ATTACHMENT 3

PROPOSED TECHNICAL SPECIFICATIONS

Marked-Up Technical Specifications Pages,

FIGURE 5.1-1 SITE AREA MAP

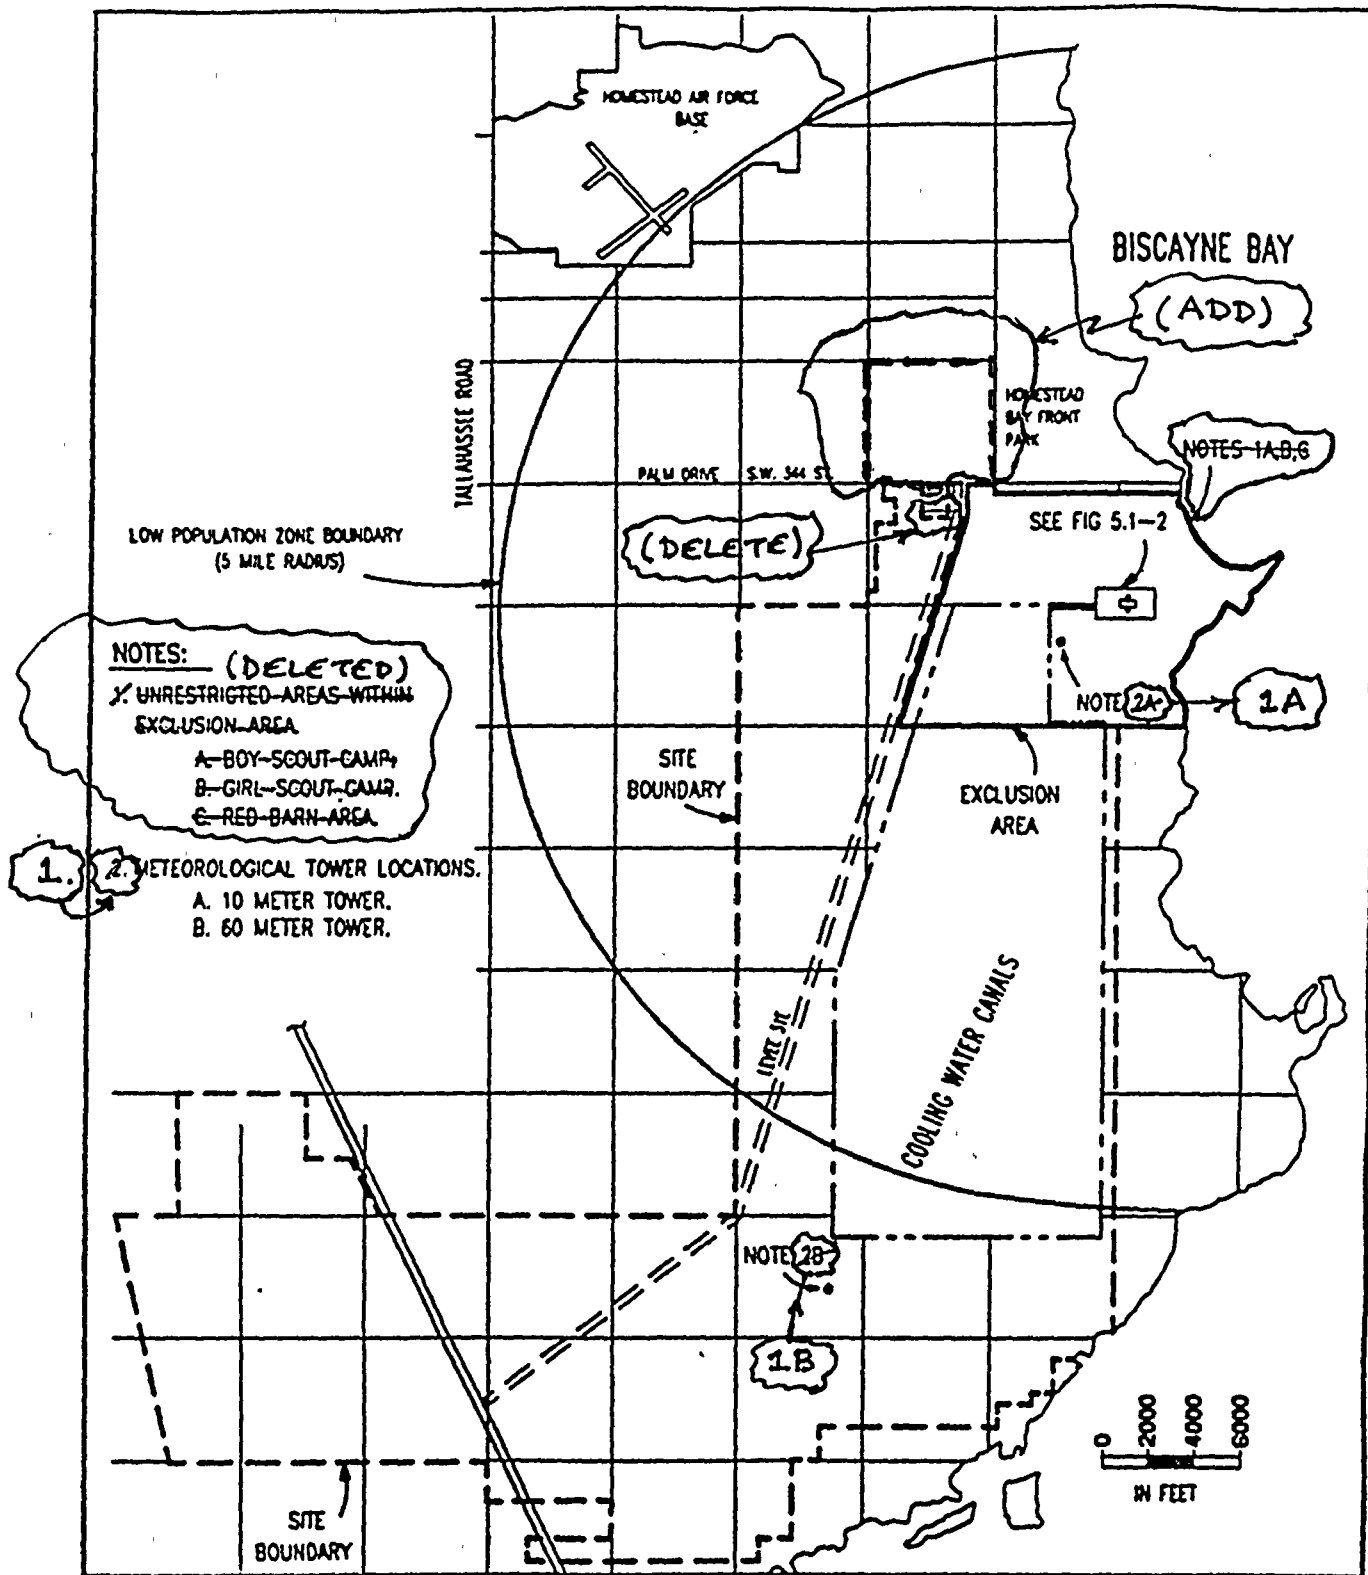
5.1.3 Information regarding radioactive gaseous and liquid effluents, which will allow identification of structures and release points shall be as shown in Figure 5.1-2. ~~Definition of UNRESTRICTED AREAS within the SITE BOUNDARY that are accessible to MEMBERS OF THE PUBLIC~~ shall be as shown in Figure 5.1-1.
